Roundabout Construction on MS 15 at Lamey Bridge Road, known as State Project No. SP-0022-01(081) / 106636301 in Harrison County.

ADDENDUM

STATE	PROJECT NO.
MISS.	SP-0022-01(081)

LIGHTING INDEX, LEGEND & GENERAL NOTES INTERSECTION OF SR 15 AND LAMEY BRIDGE ROAD	
WORKING NUMBER	COUNTY: HARRISON
FILE NUMBER	PROJ. NUM.: SP-0022-01(081)
DATE	FILENAME: L.L.TE.01.DGN
DESIGNER	DESIGN TEAM: MICHAEL BAKER GROUP
DATE	DATE: 2015
SHEET NUMBER	4001

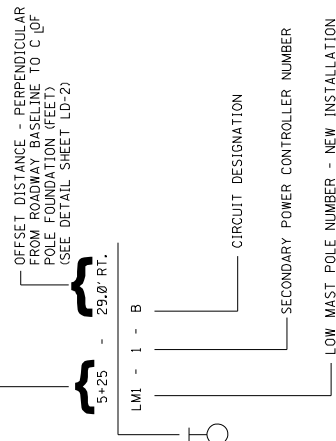
LUMINAIRE MOUNTING HEIGHT: 40'-0"
 LED LUMINAIRES: 315 WATTS
 Δ LUMINAIRE DATA: Δ LUMINAIRE SHALL MEET THE REQUIREMENTS OF SUBSECTION 907.123.09
 LUMINAIRE DISTRIBUTION: FULL CUTOFF I.E.S. TYPE III
 DEPRECIATION FACTOR: L.L.F. = 0.75
